TOWN OF KITTELY

Planning Board Meeting January 25, 2024

ITEM 2 – 47 Cutts Road – Major Conservation Subdivision Plan – Preliminary Review

**RE: Major Conservation Subdivision – Preliminary Completeness Revisions
Twin Oaks Subdivision (Tax Map 60, Lot 10-3)
47 Cutts Road, Kittery, Maine**

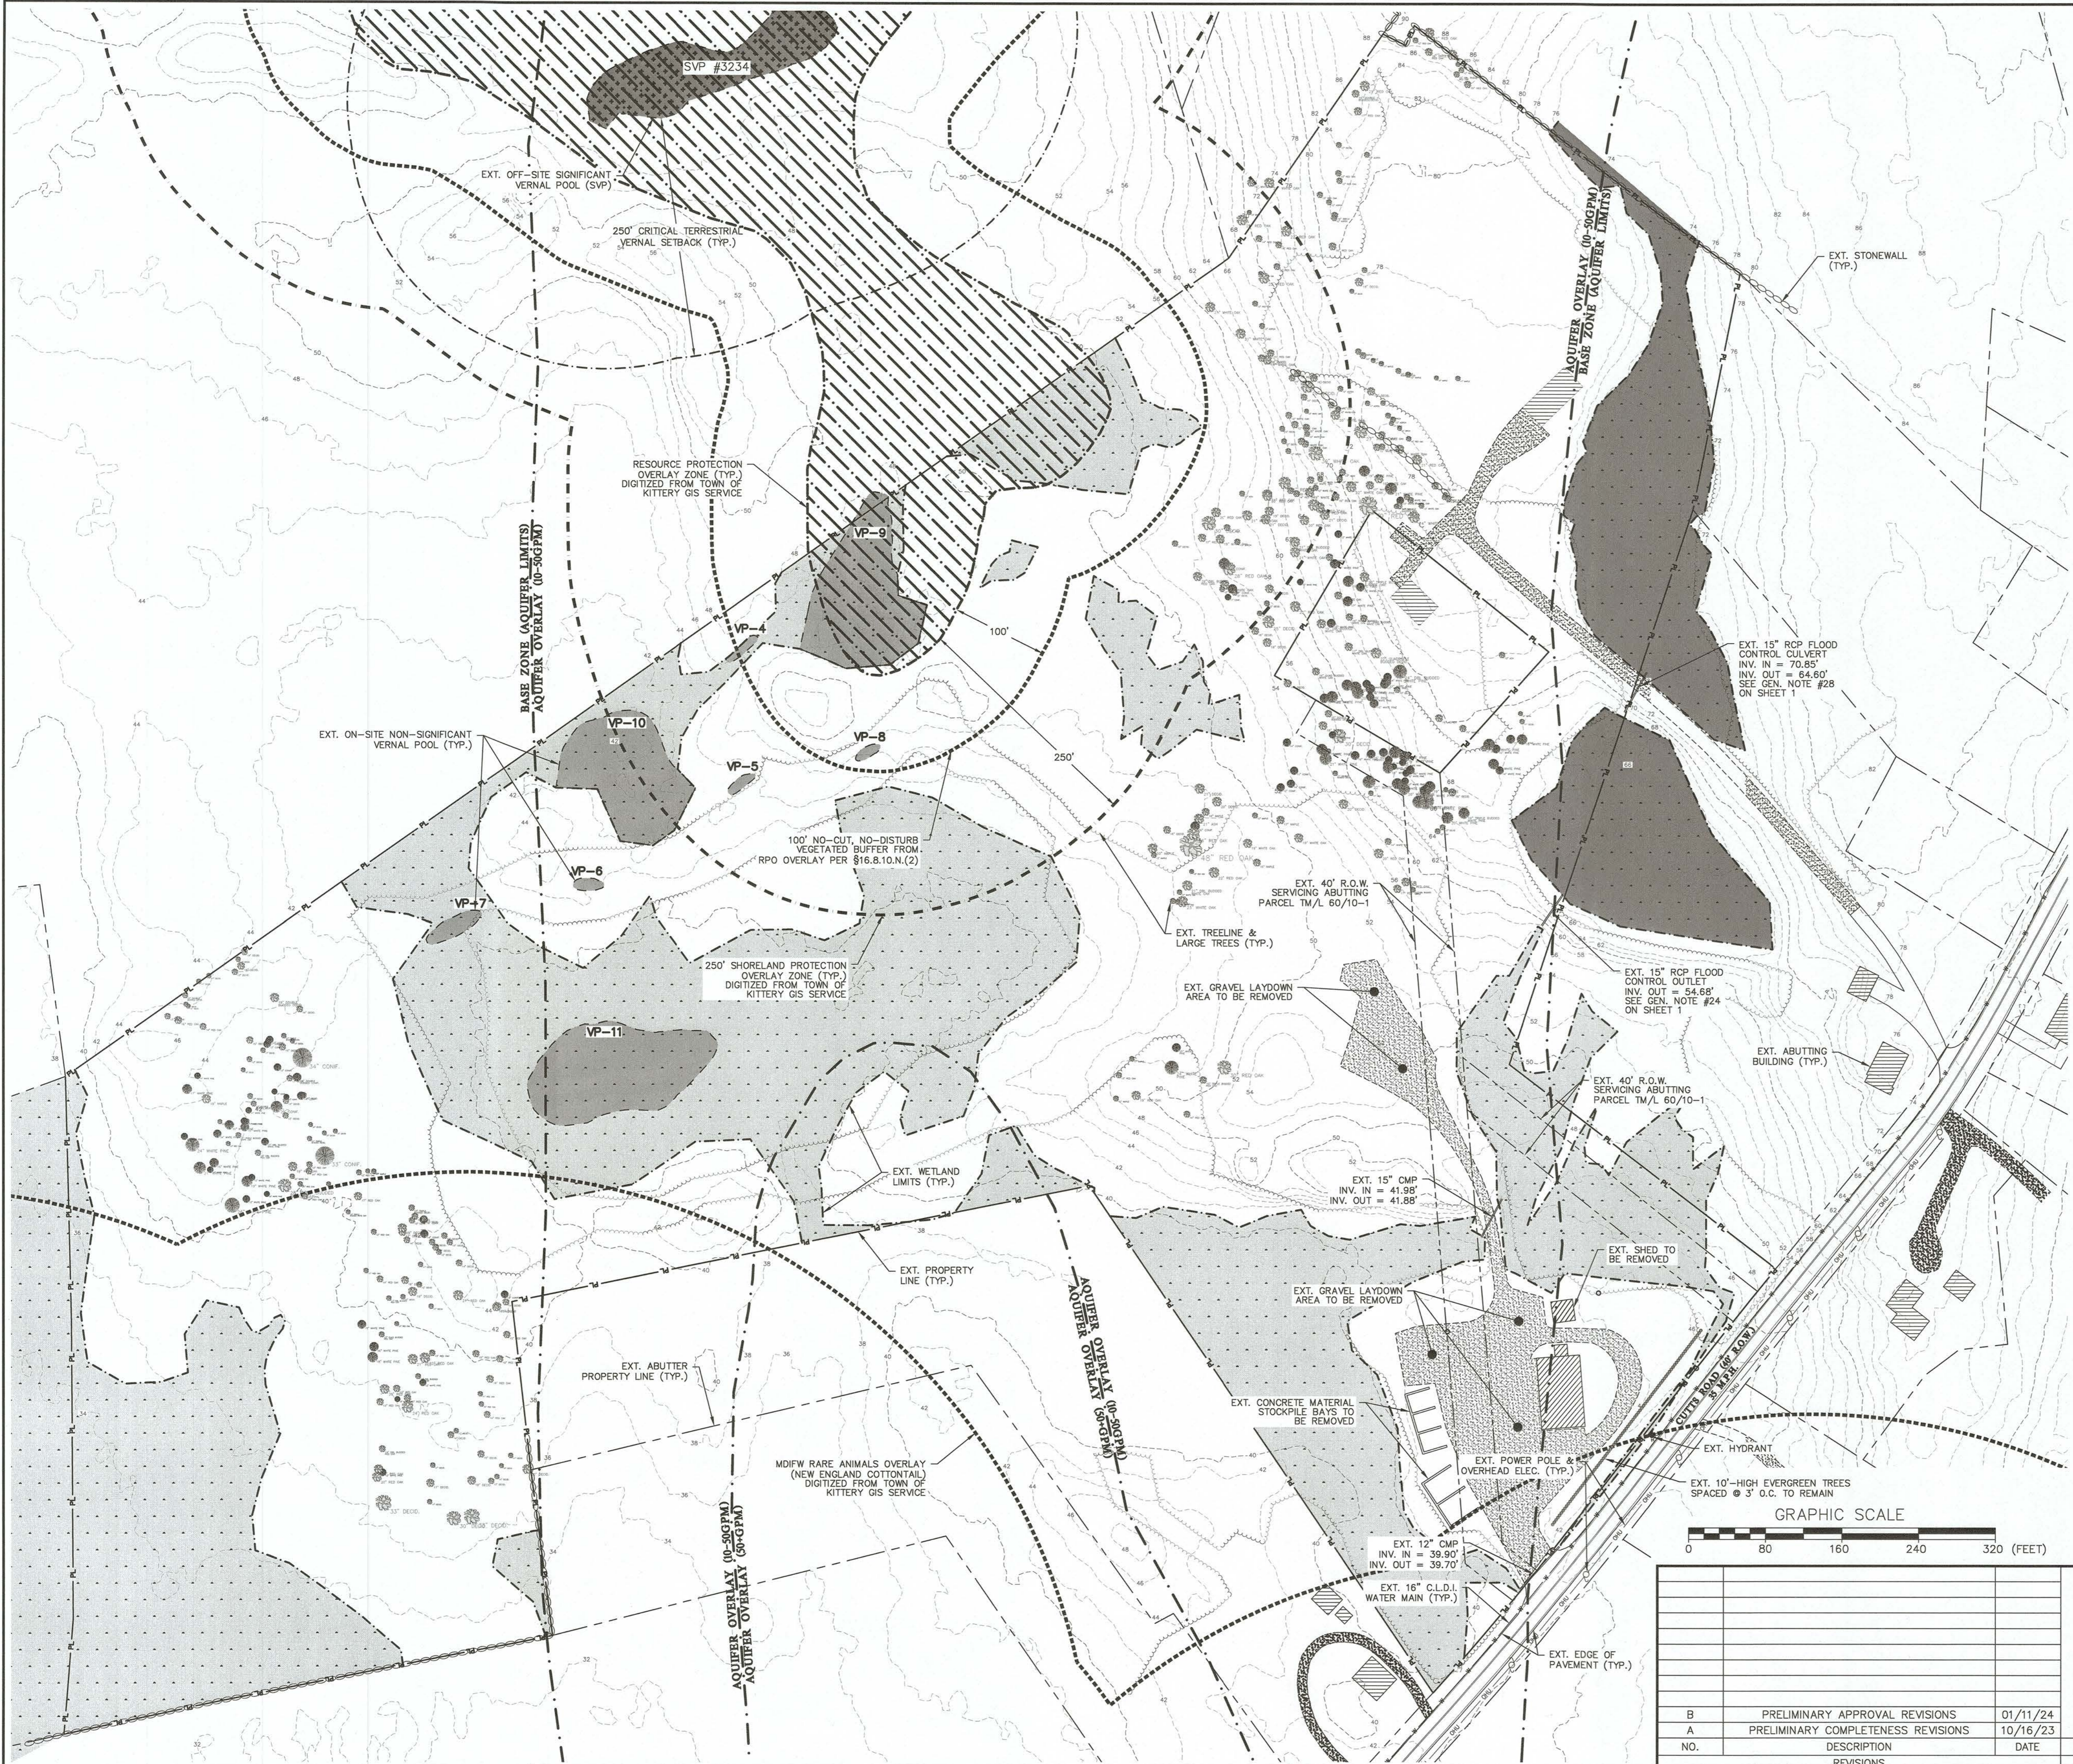
- 128 5. Police and Public Works have asked that a stop sign be installed at the
129 intersection of Acorn Lane onto Cutts Road. While this isn't required, planning
130 staff strongly suggest this, as the 40-foot vegetative buffer along Cutts Road will
131 reduce visibility.

- 138 7. There appears to be a minor visual error showing a stone wall crossing the Acorn
139 Lane ROW. This should be corrected as part of the final plan submission, any
140 stone wall in the area should be identified.

§16.10.6.F	Vegetated buffer located on front lot line, a minimum width of 40 feet	The standard appears to be satisfied. Note 22 on sheet 1 of the plan set states existing vegetation in the buffer area will remain.

- General Notes #1, #6, #7, #15, and #18 on Sheet 1 have been revised to reflect the change in overall Lot count (from 13 to 12) as well as the relocation of two lots as described above. The proposed subdivision maintains its compliance with open space, lot coverage, and devegetated area calculations.

- General Note #12 on Sheet 1 has been revised to include language describing the stricter Shoreland Protection Overlay requirements of §16.10.5.G. which were discussed above.

- General Note #24 on Sheet 1 has been added to speak to the capping, maintenance, and protection of the existing outfall and gate valve which serve as an emergency flood control to the southern on-site pond.

GRADING & UTILITIES PLAN
TWIN OAKS SUBDIVISION
47 CUTTS ROAD, KITTERY, MAINE
TAX MAP 60, LOT 10-3

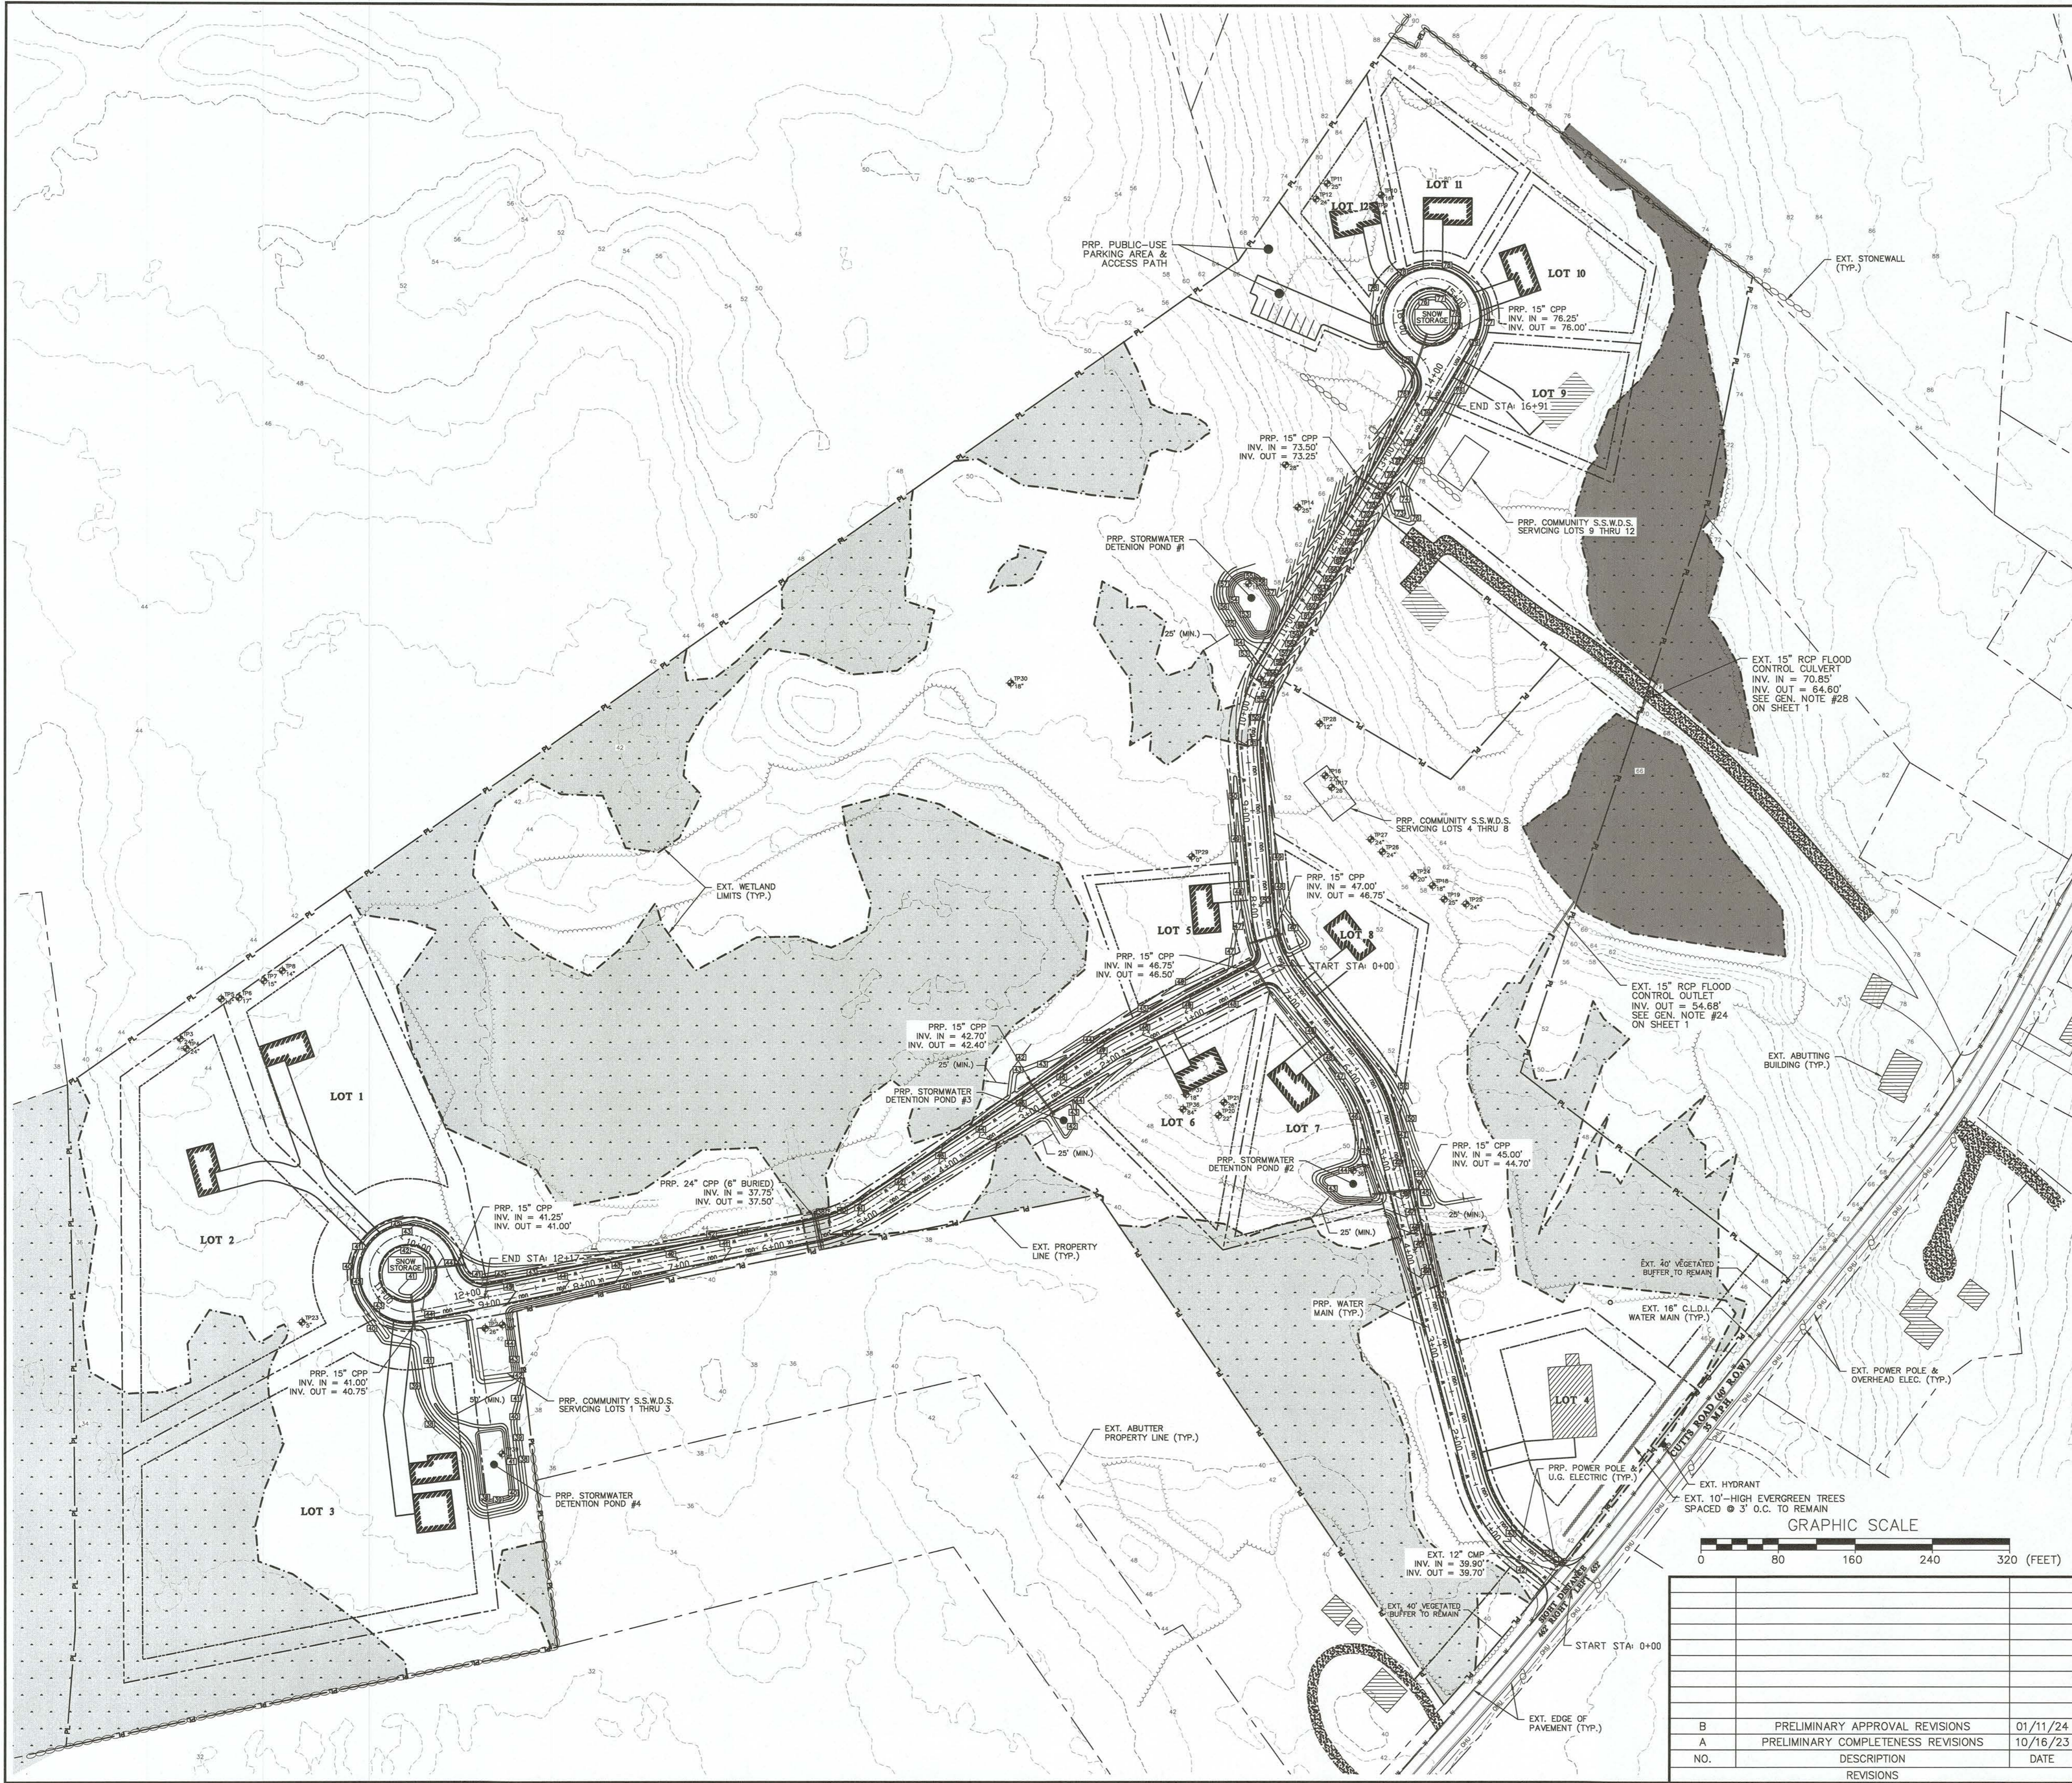
- 161 13. Following planning board and staff feedback, the revised plan set now shows snow
 162 storage in the proposed cul-de-sac areas to reduce the risk of pollutant
 163 contamination in the abutting natural resources.

- 4.) SNOW STORAGE LOCATIONS ARE DEPICTED ON THE PLANS. ROADSIDE SNOW STORAGE IS NOT ALLOWED IN THE ROADSIDE VEGETATED AND ARMORED SWALES, INSTEAD BEING REQUIRED TO BE LOCATED IN THE CENTER OF BOTH PROPOSED CULS-DE-SAC. IN AN INSTANCE WHERE THE DEVELOPED LOT REACHES ITS CAPACITY FOR SNOW STORAGE, ALL EXCESS SNOW SHALL BE CARRIED OFF-SITE.
